# UNITED STATES PATENT AND TRADEMARK OFFICE

**Office Action Summary**

10/614,271

SWENSON, DAVID C.

# **ATTACHMENT # 1**

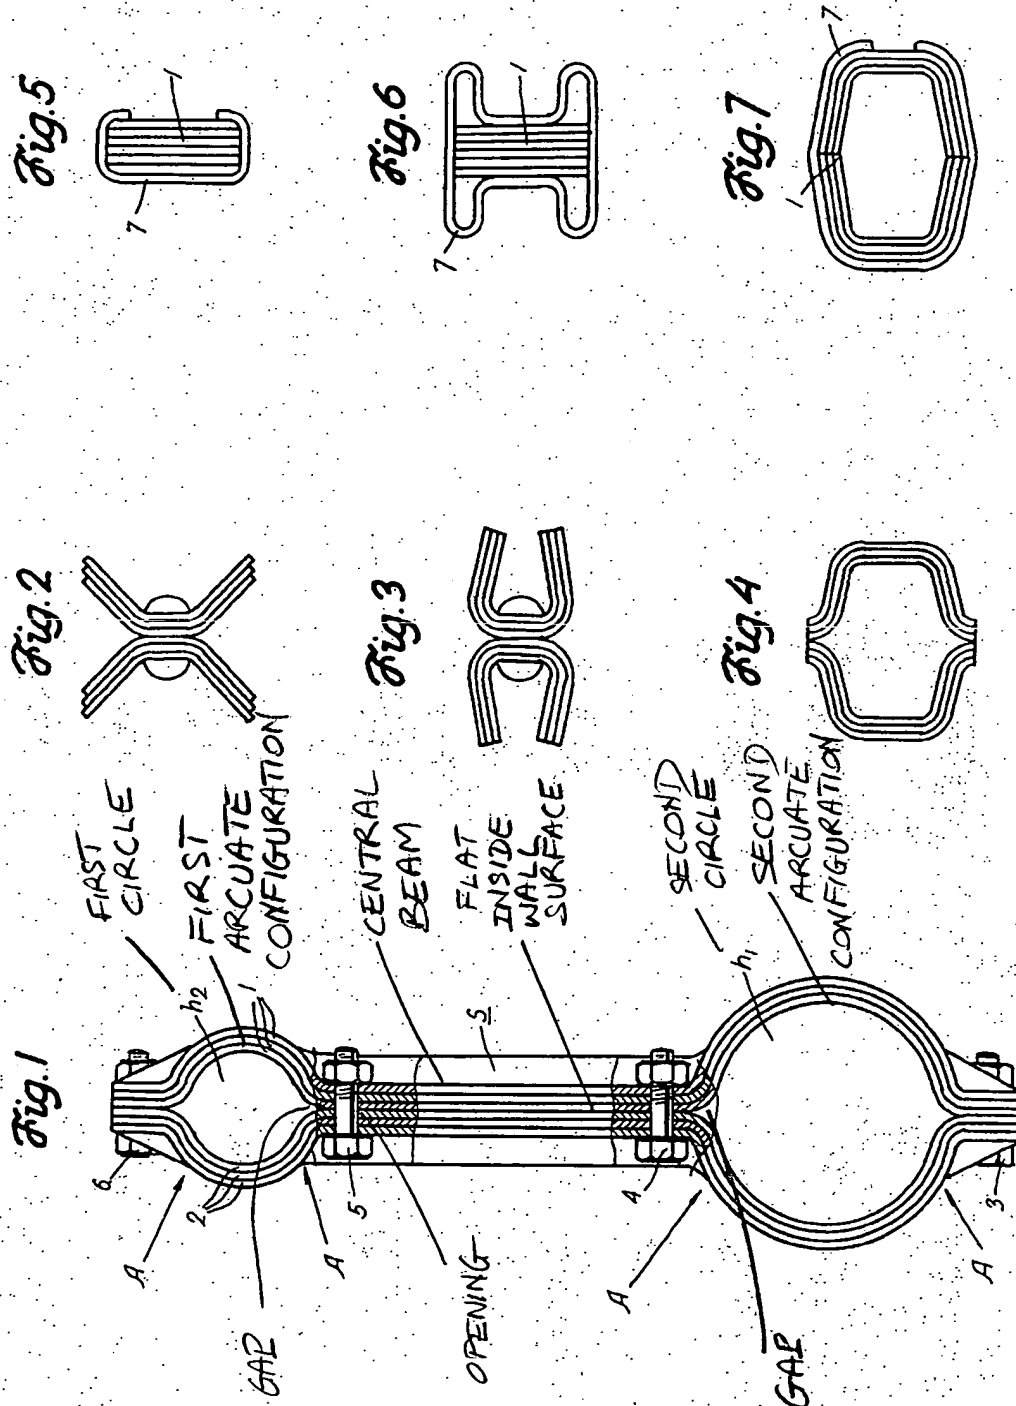
(i) two symmetrical rods 1 and 2 of equivalent size; each said rod 1 or 2 manufactured of modified metal; each said rod 1 or 2 comprising a central beam S having a near end and a distal end and an inside wall surface (unnumbered. See Attachment 1); each distal end terminating in a first arcuate configuration (Att. 1); each near end terminating in a second arcuate configuration (Att. 1) such that upon joining the rods 1 and 2 together the first arcuate configurations form a first circle  $h_2$  and the second arcuate configurations form a second circle  $h_1$ ; each of the arcuate configurations having a near end and a distal end wherein each distal end has an opening (Att. 1) at the terminus thereof to receive a fastening device 3-6;

(ii) each said rod 1 or 2 having an opening located in the central beam between the first arcuate configuration (Att. 1) and the second arcuate configuration (Att. 1), wherein all openings are directed through the inside wall surface thereof. Id., claims 1-9.

Regarding claim 5, the rods 1 and 2 are assembled such that there is a gap (Att. 1) provided between the inside surface of the beams.

Regarding claim 6, the inside surface of each beam between the first and second arcuate configurations is flat (Att. 1).

Regarding claims 9, the opening (Att. 1) located between the first arcuate configuration and the second arcuate configuration is not at the midpoint.

## **ATTACHMENT # 2**

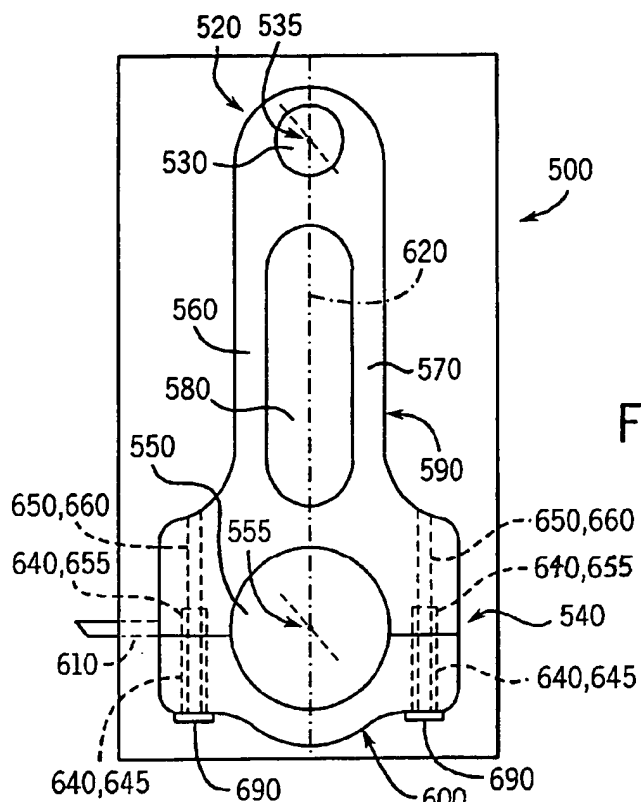
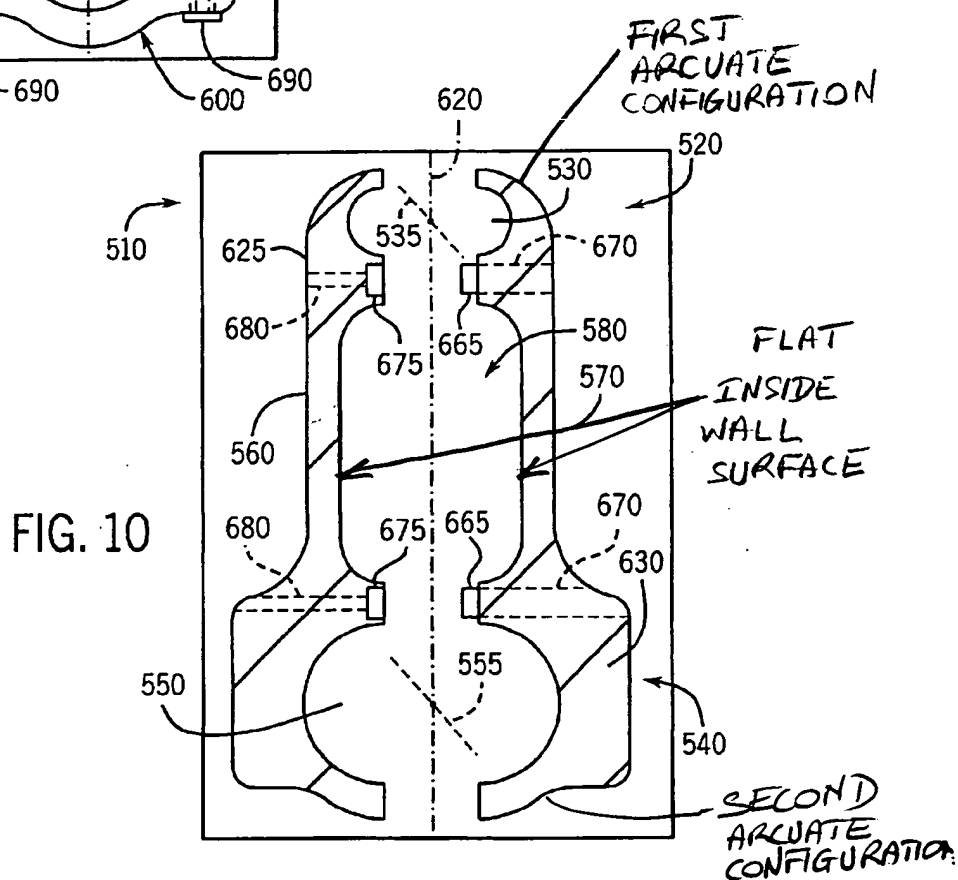
(i) two symmetrical rods 560 and 570 of equivalent size; each said rod 560 or 570 manufactured of modified metal; each said rod 560 or 570 comprising a central beam having a near end and a distal end and an inside wall surface (unnumbered. See Attachment 2); each distal end terminating in a first arcuate configuration (Att. 2); each near end terminating in a second arcuate configuration (Att. 2) such that upon joining the rods 560 and 570 together the first arcuate configurations form a first circle 530 and the second arcuate configurations form a second circle 550; each of the arcuate configurations having a near end and a distal end wherein each distal end has an opening 670, 680 at the terminus thereof to receive a fastening device;

(ii) each said rod 560 or 570 having an opening 580 located in the central beam between the first arcuate configuration (Att. 1) and the second arcuate configuration (Att. 1), wherein all openings 670, 680, 580 are directed through the inside wall surface thereof. Id., claims 1-20.

Regarding claim 5, the rods 560 and 570 are assembled such that there is a gap 580 provided between the inside surface of the beams.

Regarding claim 6, the inside surface of each beam between the first and second arcuate configurations is flat (Att. 2).

Regarding claim 7, the inside surface of each beam 560, 570 contains a channel 580 therein running *essentially* the length of the flat inside surface.
